RAINAGE AND TRANSPORTATION INFORMATION SHEET

Project Title: Vermeer Sales Southwest City Drainage #: _____

**RE: GRADING AND DRAINAGE CERTIFICATION FOR
PERMANENT CERTIFICATE OF OCCUPANCY
VERMEER SALES, 9005 WASHINGTON ST. NE**

RE: REVISED DRAINAGE PLAN FOR PLUMB MECHANICAL (C17-D21) REVISION
DATED 10/19/98

SITE PLAN

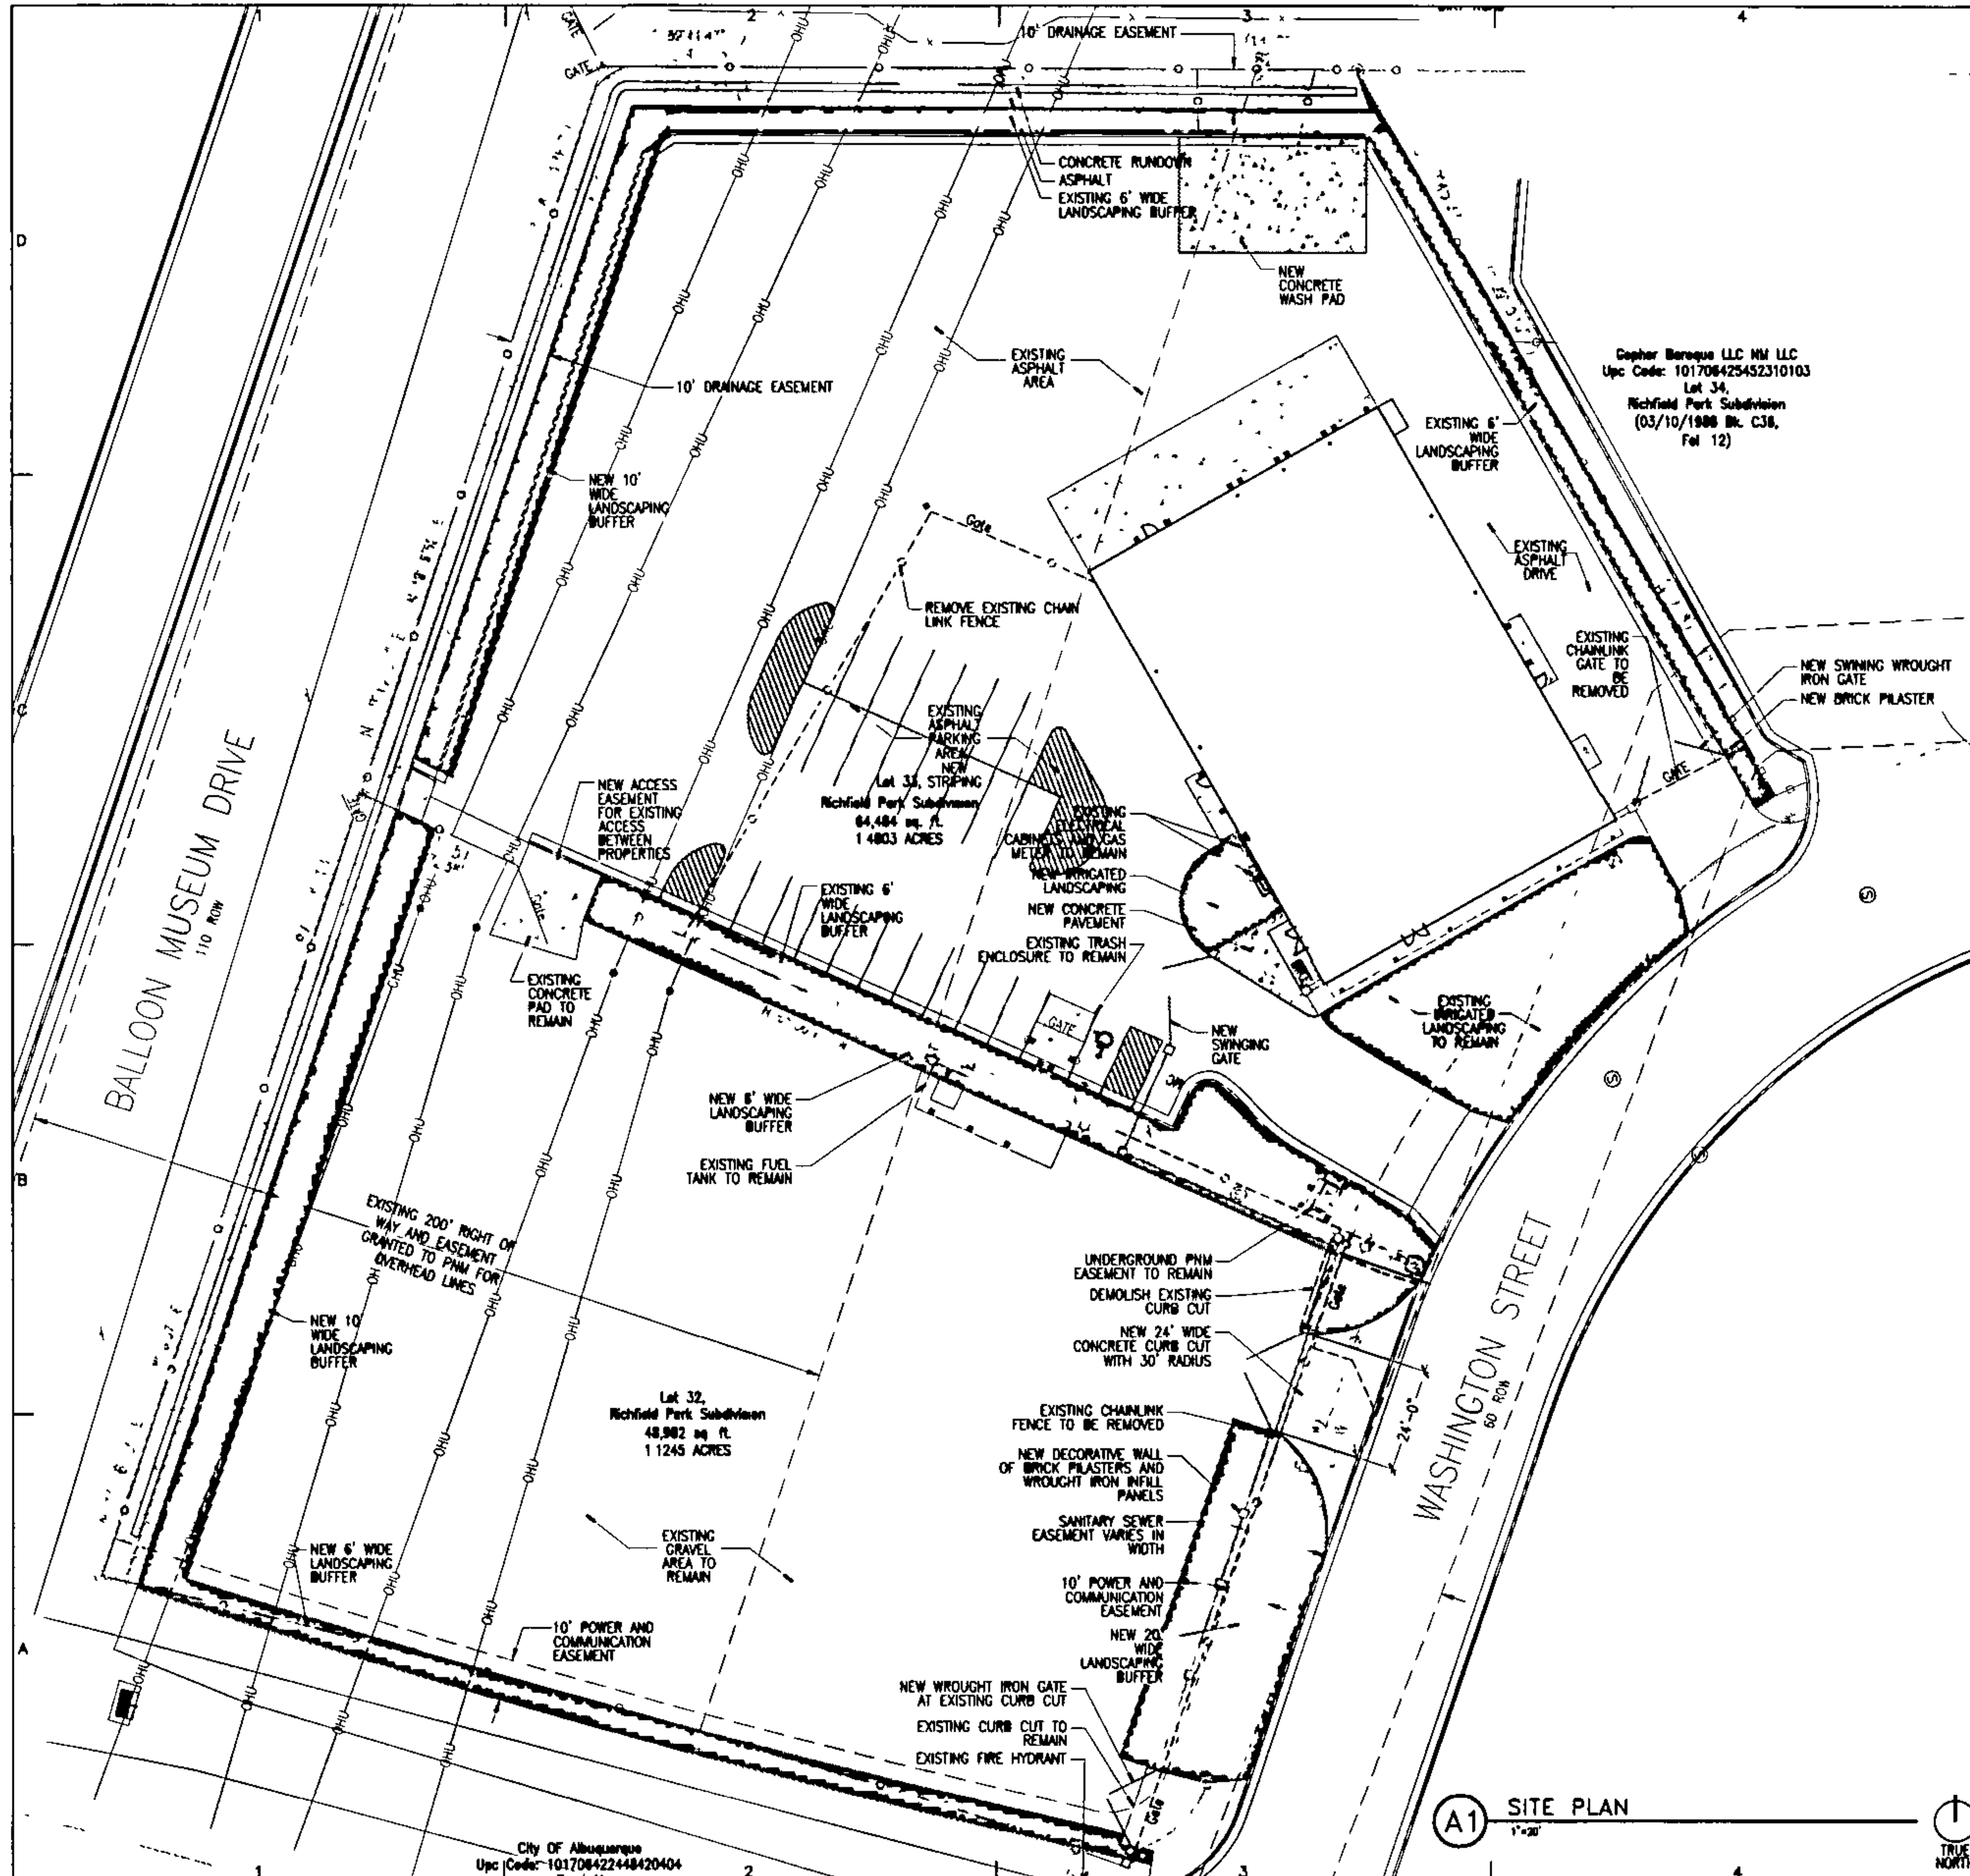
Jon,
 Finally got to clear some time.
 Seems there is a wall or fence along the western boundary that is not shown on the site plan. There is a large shadow on the aerial photograph.
 I already spoke to the architect on this one.
 You should submit a conceptual plan that addresses how the site will deal with the wash water and a brief narrative on site drainage (it is a drainage submittal). The City and AMAFCA don't want oil and sediment laden water entering the storm drain system. I mentioned to the architect about this and she mentioned an oil/water and a separate sediment separator that drains to the SAS.
